# Coexistence Analysis for multiple air-to-ground systems

**April 9, 2004**

# Overview of Proposed Coexistence Plan

# Observations regarding the proposed layout

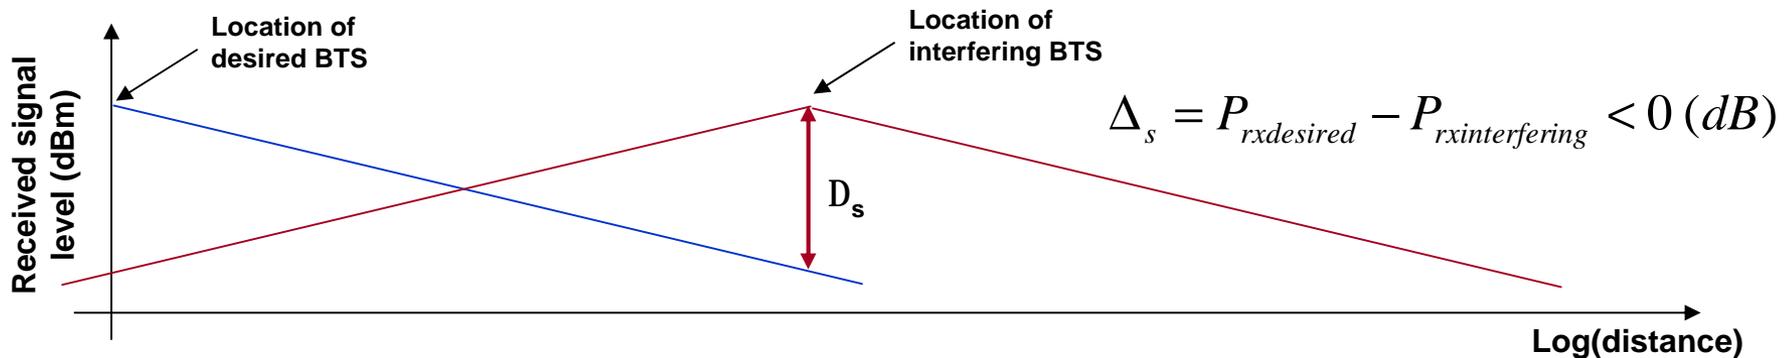
- System #2 base stations are placed where signals from system #1 base stations is weakest, creating severe interference problems.

- Without significant antenna discrimination between the two opposing system's base stations, system #1 aircraft would see a very large signal from system #2 and weak signals from their own base stations.

- Base stations from system #1 could have aircraft belonging to system #2 very close while trying to communicate with system #1 aircraft that are very far (classic near-far problem).

# Observations regarding the proposed layout (cont.)

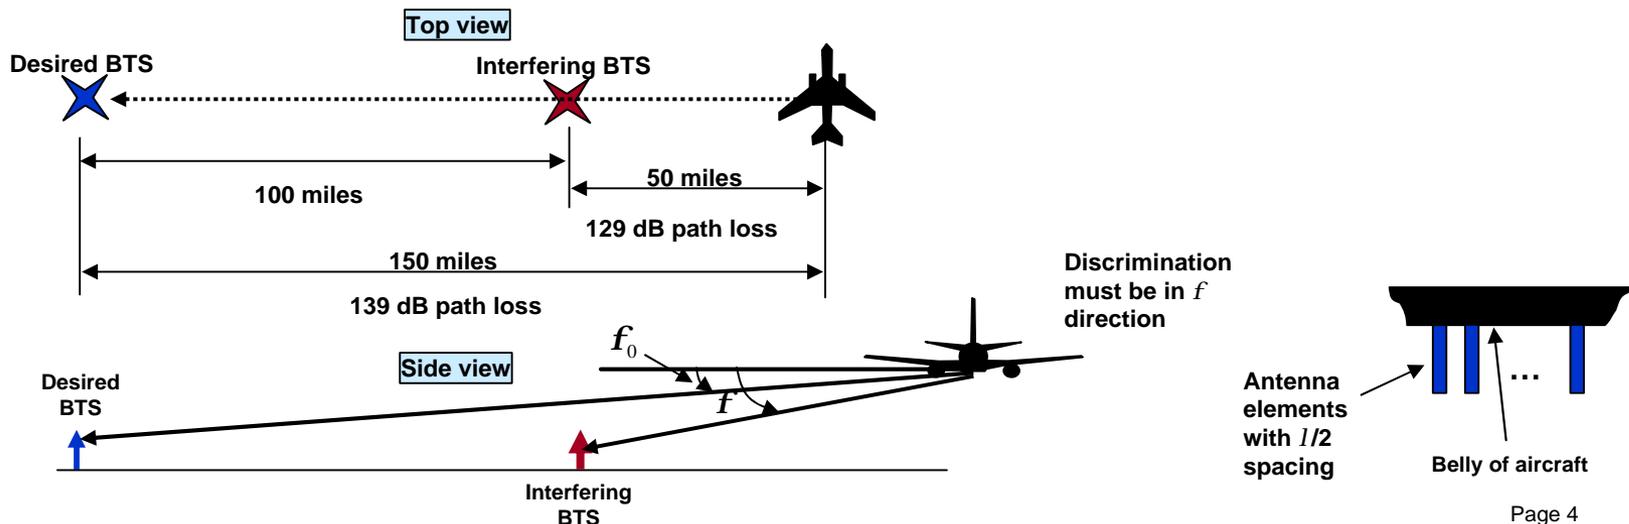
- The only way to deal with this interference problem, as was proposed, is to install adaptive antennas on both ends of the link that can form beams which aim at the desired base station, while attenuating the signal from the interfering base station through pattern roll-off.
- As we will see however, for cases where interfering and desired BTS are not separated by reasonable angles, a prohibitively high number of antenna elements is required to form a beam that is narrow enough to aim at the desired BTS, while attenuating the interferer.
  - These cases occur where the serving BTS is angularly very close to an interfering base station.
    - Airport approach and climb-out, when both systems have base stations near the airport.
    - Edge-of-network areas, such as coastal regions.

## Co-linear interfering BTSs example (cont.)

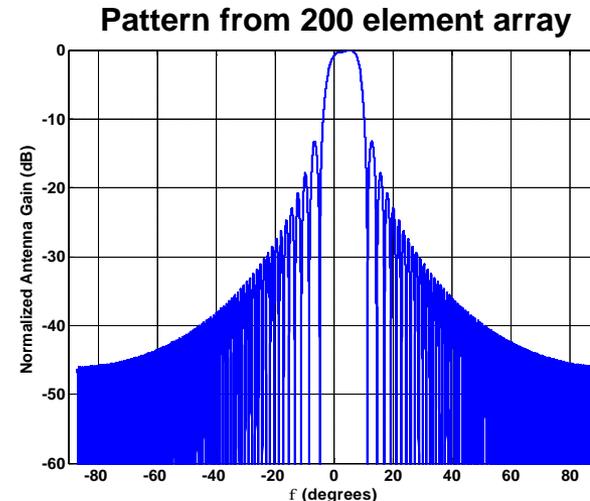
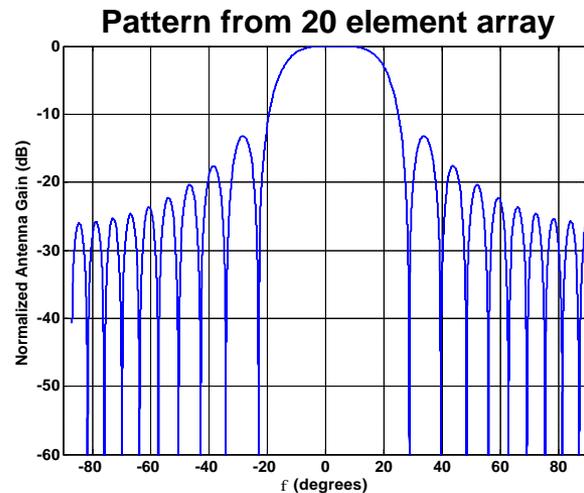
- Because of the path loss difference in the case shown on the previous slide, the interfering signal must be attenuated by 10 dB + minimum SINR required to complete call.

- We can form a beam toward the desired base station that will also attenuate the signal to the interferer.
- The question is: how many elements do we need in order to attenuate the interfering signal enough?

- Assume we only need 0 dB SIR to complete the call (this will result in very low data rates, but the call will be connected).
  - We must find the number of elements that make:  $20 \log_{10}(G(\mathbf{f}; N)) = -10$

- We need 190 elements in the dimension along the wing to achieve this.
  - We must maintain this performance regardless of the aircraft azimuthal orientation, so we need a square array.

- This results in a square array with  $190^2 = 36,100$  elements.
  - This array would be 100 feet on a side at 895 MHz and would require 36,100 receiver chains.

- The absurd number of elements required show that it is clearly very difficult to form a narrow enough beam to attenuate a near co-linear interfering BTS using a belly mounted array.

# Chicago O'Hare example

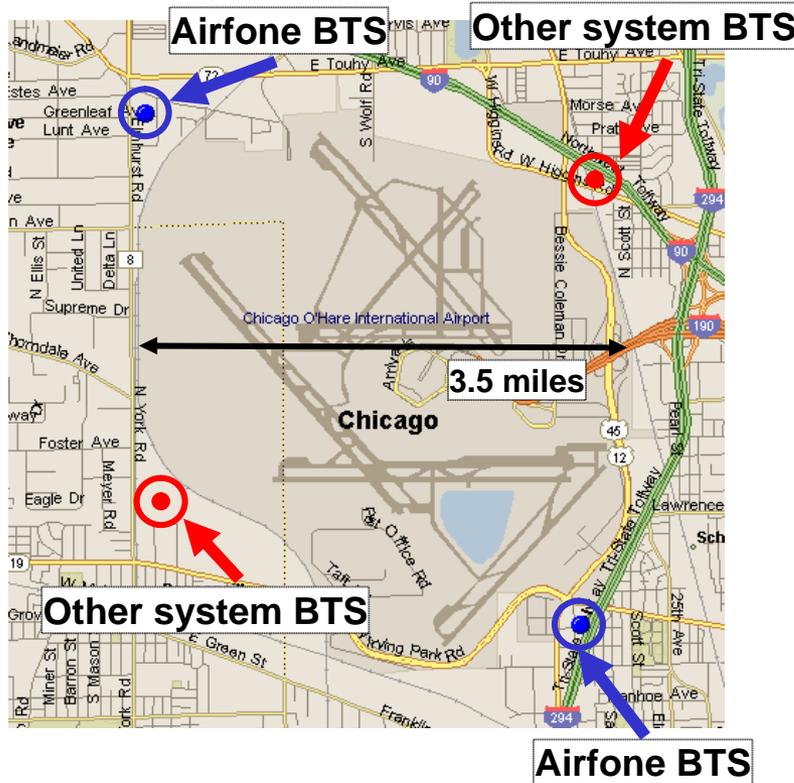
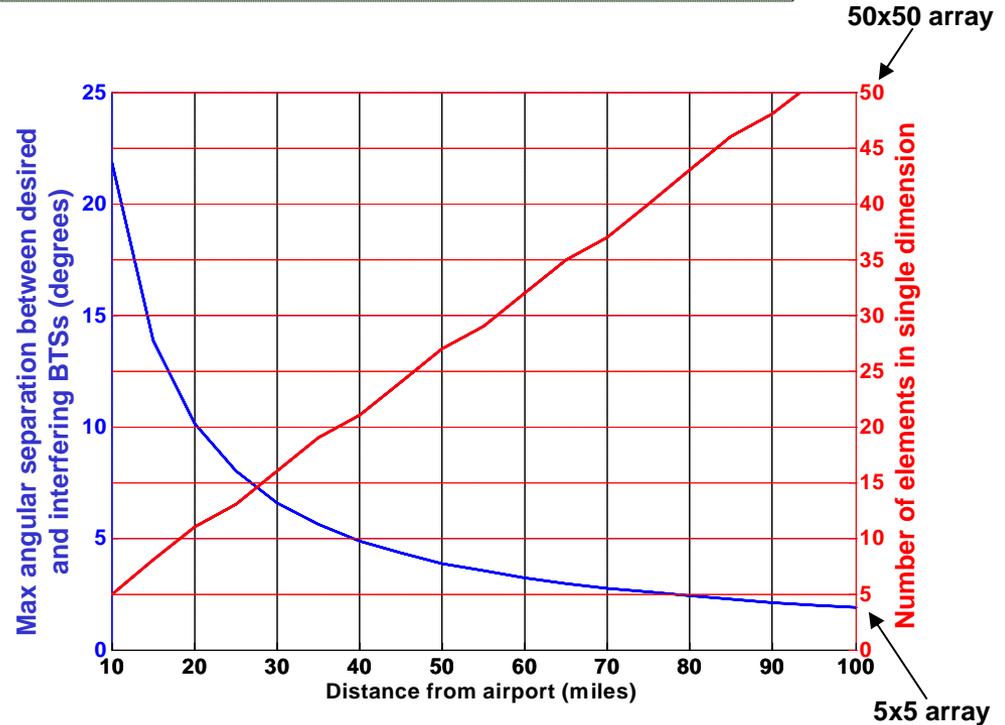
- In this specific example, we can use angular separation in azimuth to discriminate between desired and interfering BTSs (no longer an endfire array).
- We determine the number of elements necessary to put the interferer outside the 3 dB beamwidth (may not be enough attenuation, but is best case).
- As we get farther from the airport, all base stations (desired as well as interfering) look as if they are co-located.

- Even at the closest reasonable point (10 miles), where azimuthal angular separation is greatest, a 5x5 array is needed to reduce the interferer by 3 dB.

# Simplified block diagram comparison

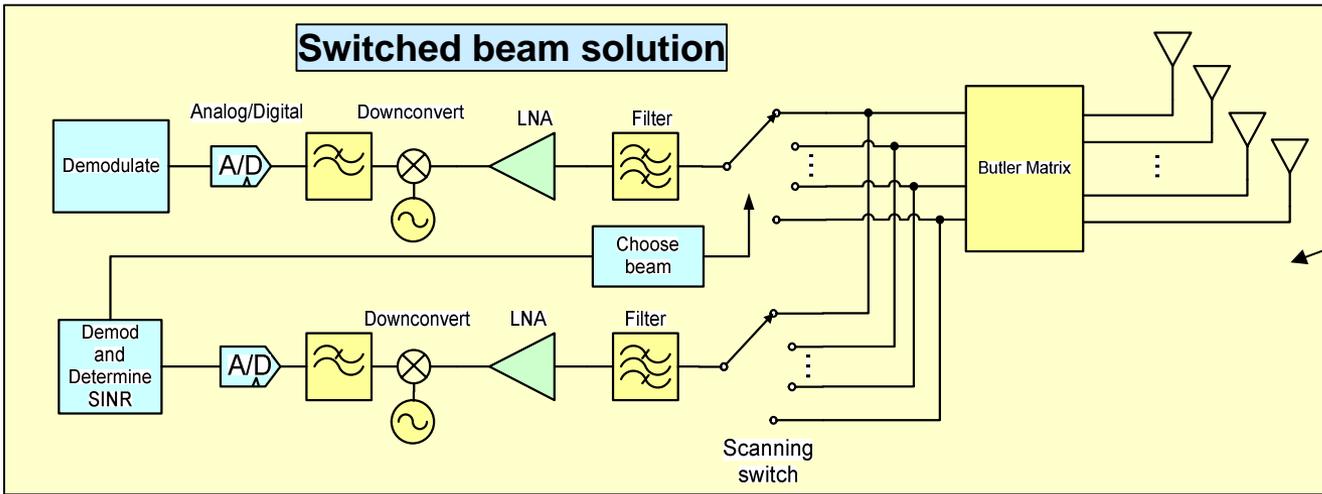
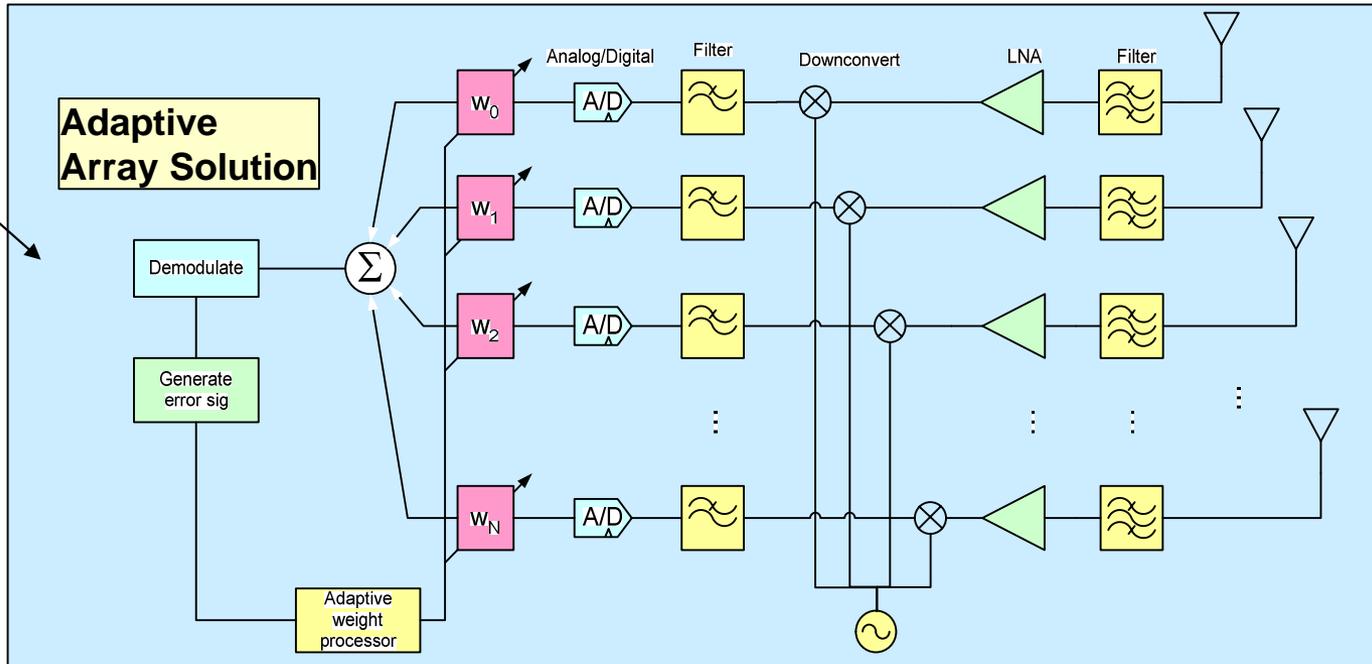
More costly and more complex solution
